VILLAGE OF SCIO  
HARRISON COUNTY, OHIO

HILLTOP ST. AND MAIN ST. SANITARY SEWER EXTENSION

ADDENDUM #3

THRASHER PROJECT #T20-11019

SHEET NO.  
**1**

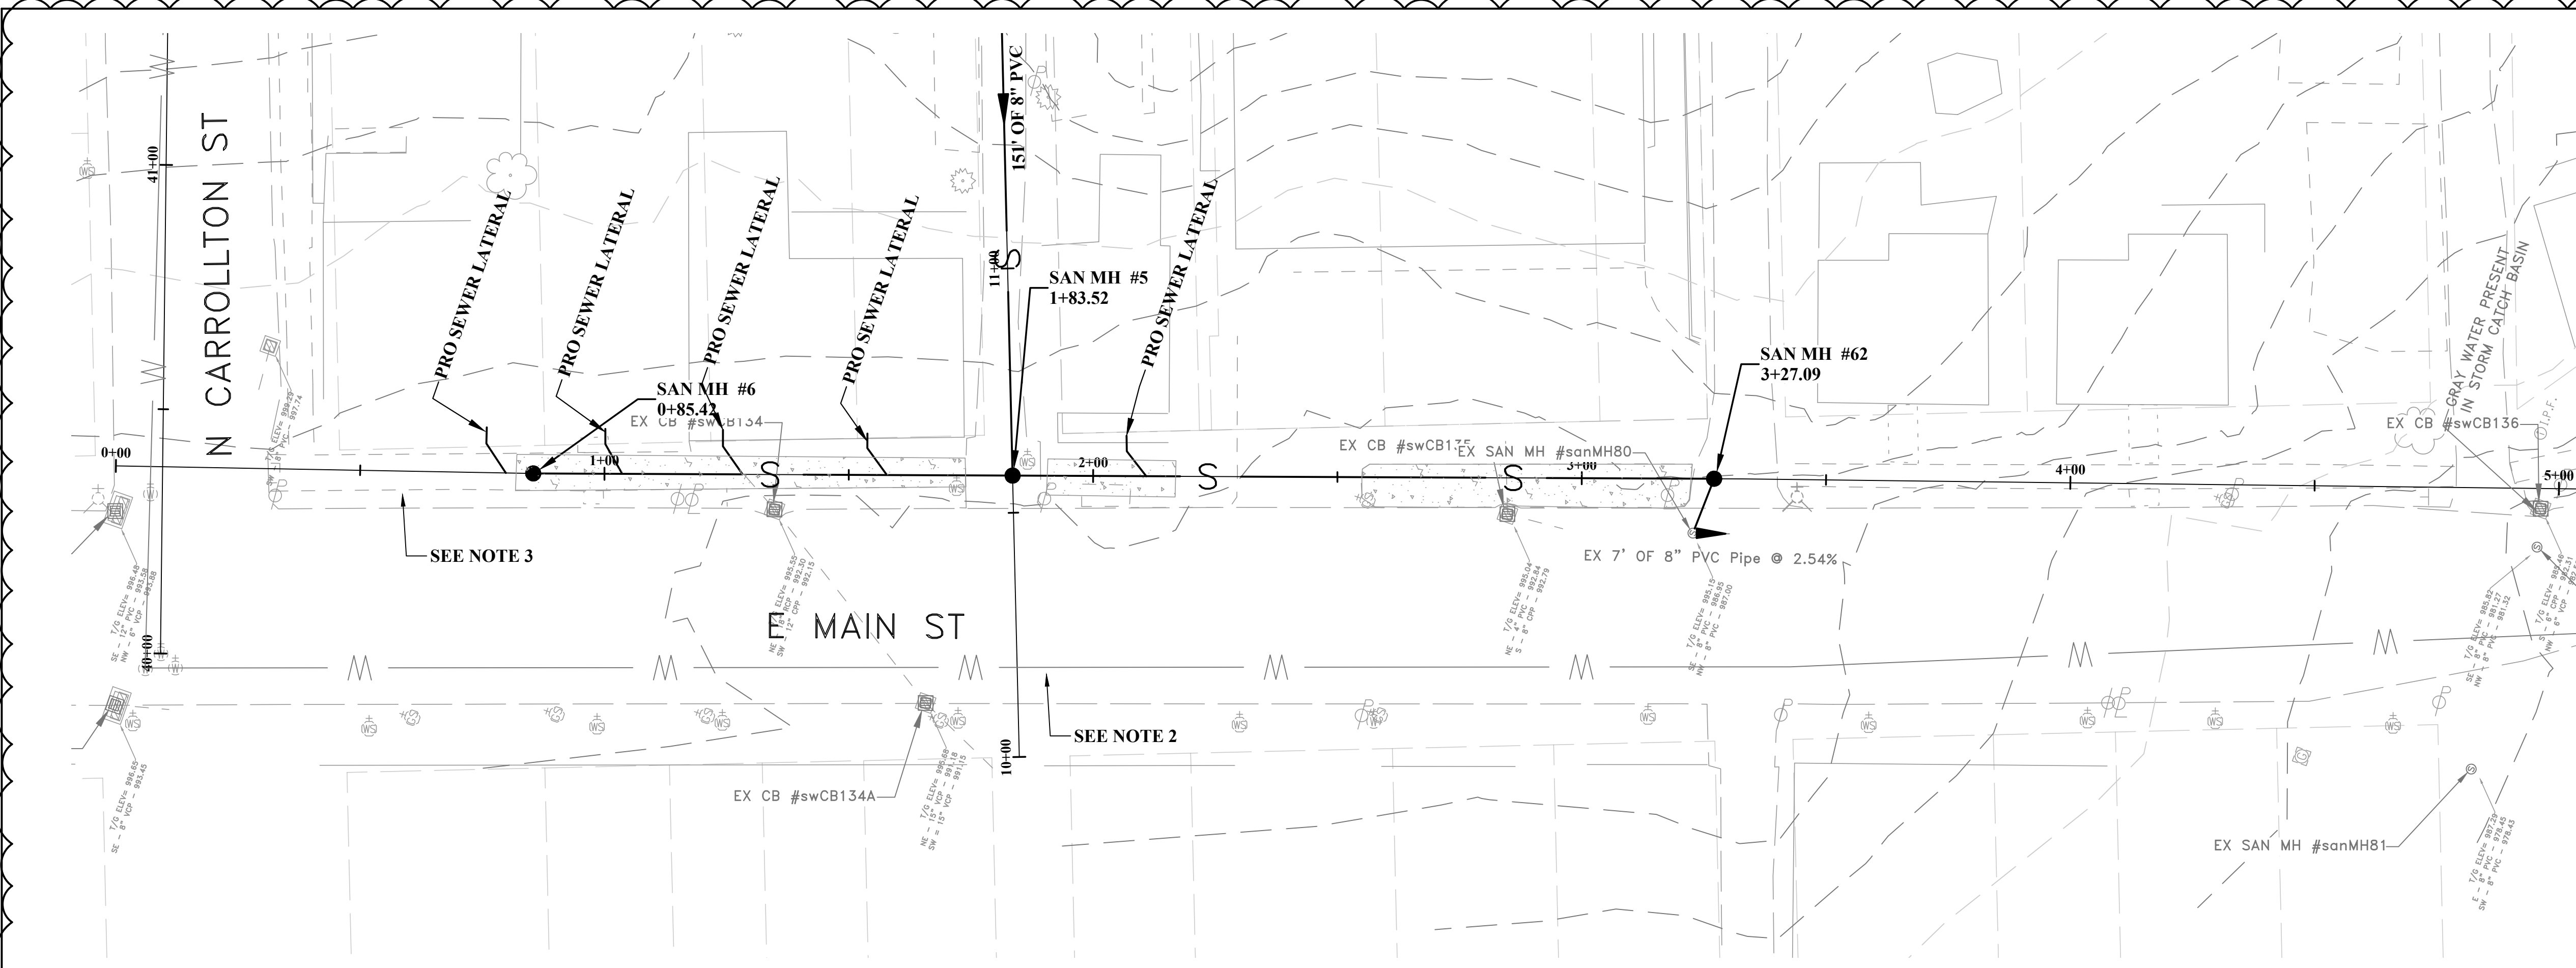
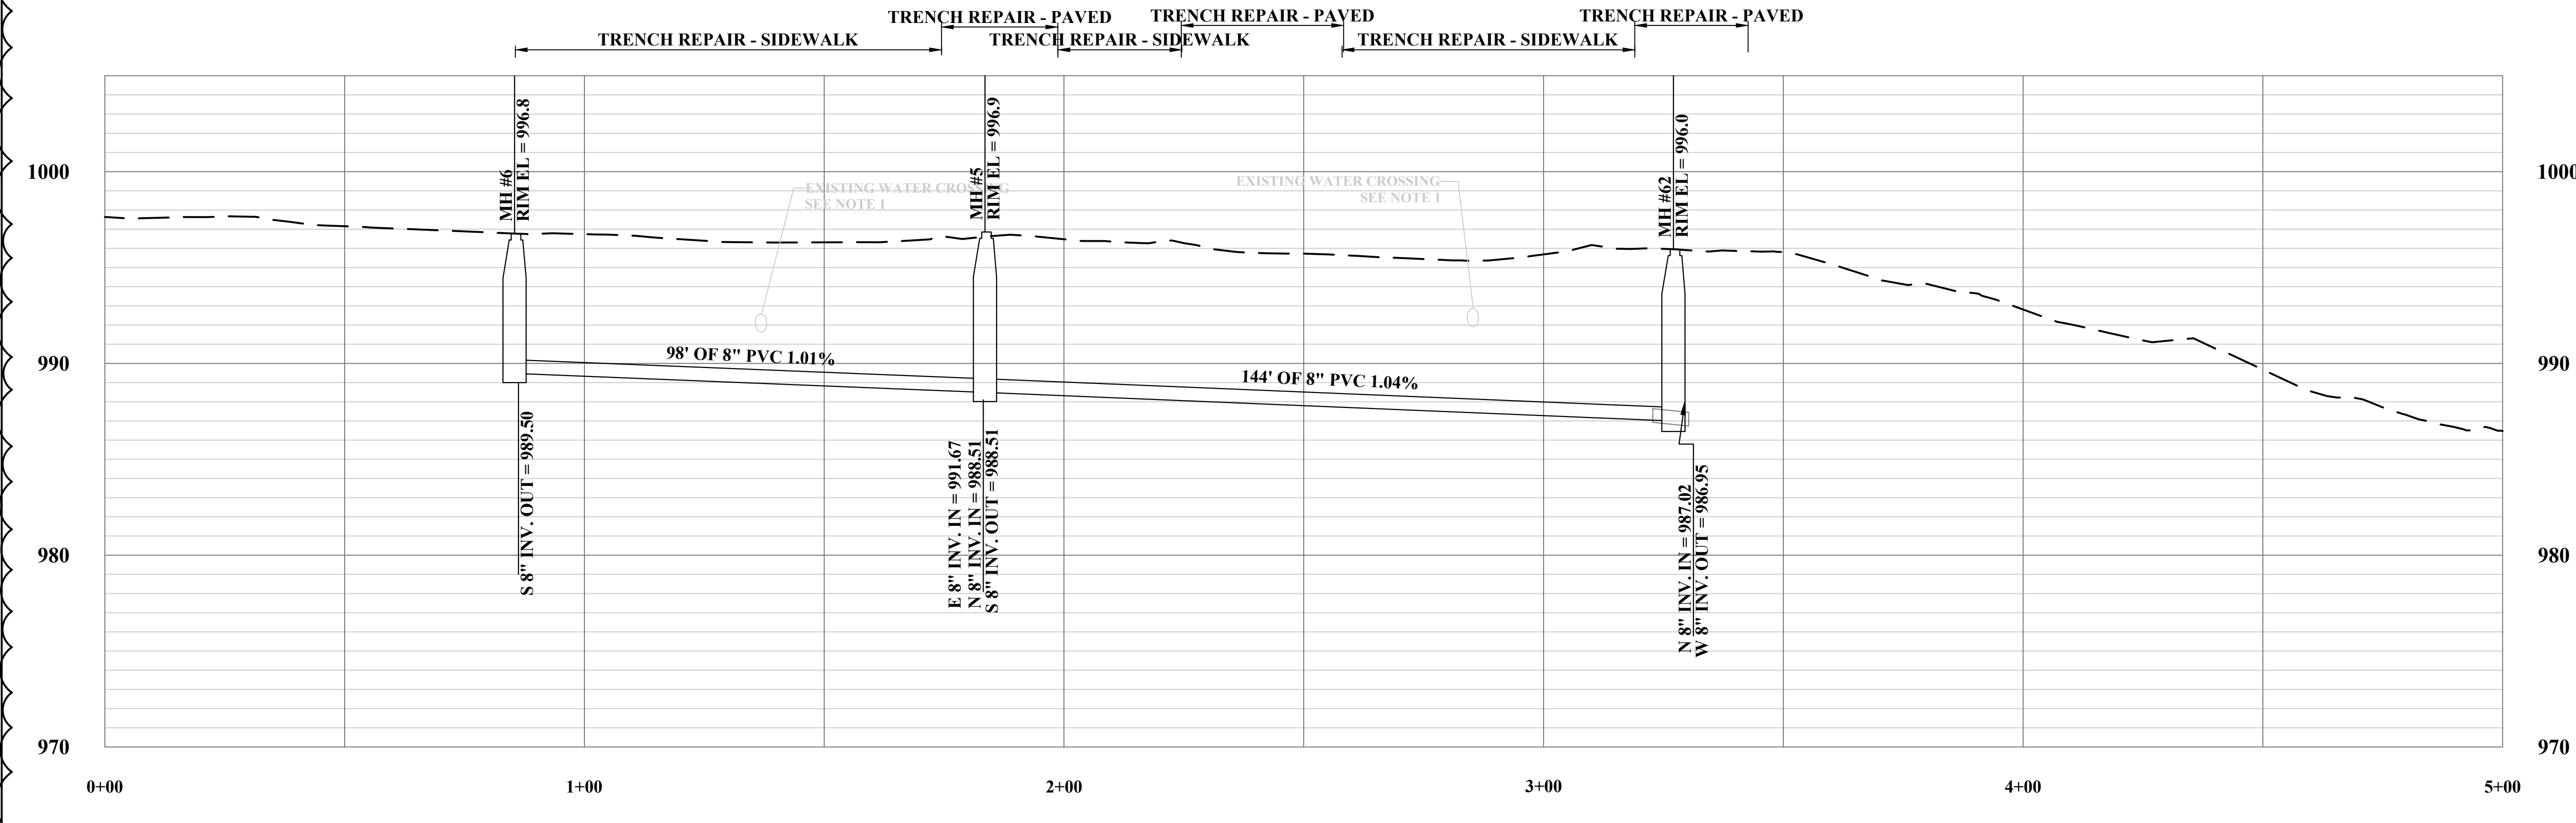
- c. The depth of that line? (there is no proposed invert elevation for a line entering the structure from the south)

The line extending south of manhole 62 is 8" PVC. The proposed laterals have been removed from the project.

The proposed sanitary does not extend past manhole 62.

The inverts that will need to be tied into manhole 62 are as updated on sheet 1. The proposed sewer will be tied into the existing manhole 80.

**D2**

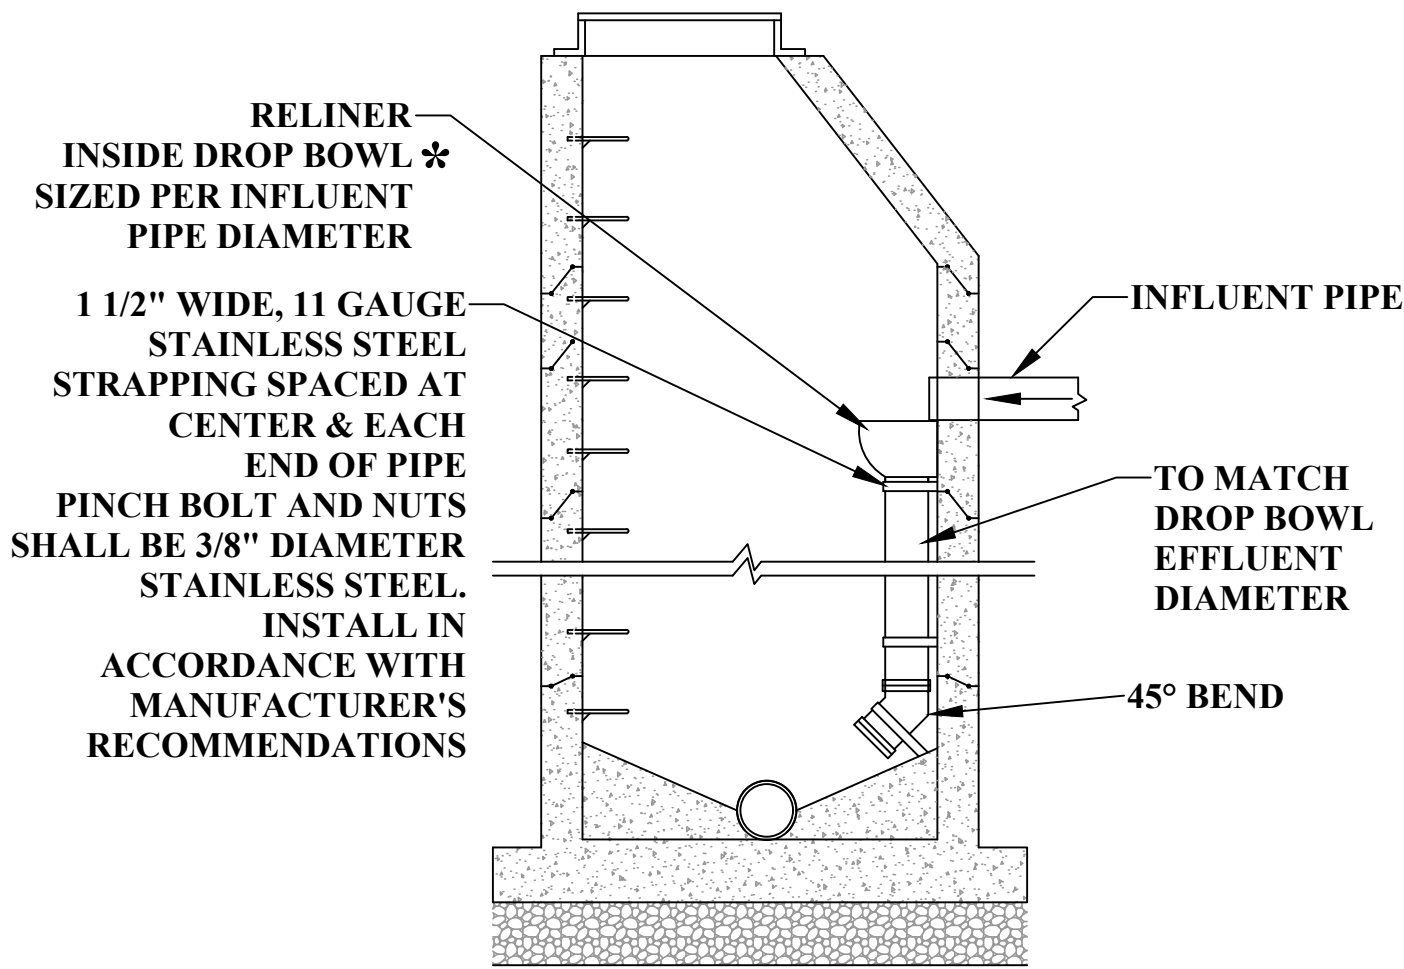
Manholes 5, 4 have inverts coming above the outlet that are 3-4' above, will these manholes need to be considered a drop? If so, is there a detail of the manhole with a drop?

Manholes with an invert drop more than 18" will require an inside drop assembly. A detail is being added to Sheet D2 of the plans.
